WEST SUSSEX COUNTY COUNCIL
STRATEGIC PLANNING CONSULTATION

SUBJECT: LU/182/15/PL - Variation of conditions 4, 6, 7, 8, 39 and 42 imposed under planning reference LU/47/11/ relating to list of plans, illustrative masterplan, CHP plant building, Design Statement, bus stops & traffic improvements.

LOCATION: Land North of Toddington Lane, Littlehampton, BN17 7PP.

Further information received in response to WSCC comments dated 9th February 2017.

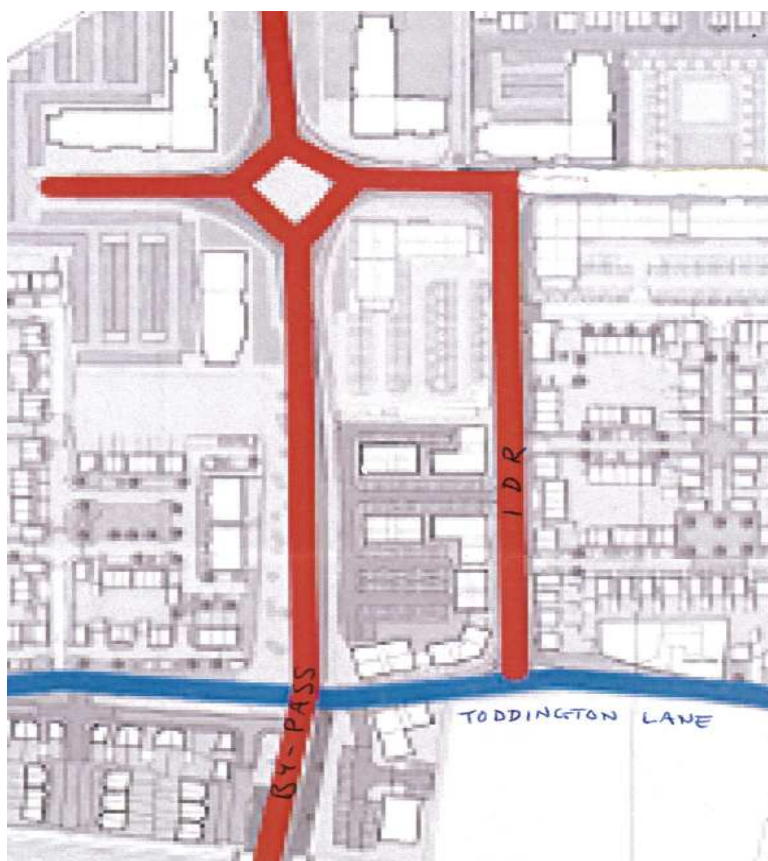
- Extent of road adoption – WSCC will adopt roads in red as shown below given their strategic nature (blue line is existing adopted public highway): no comment required. **Noted.**
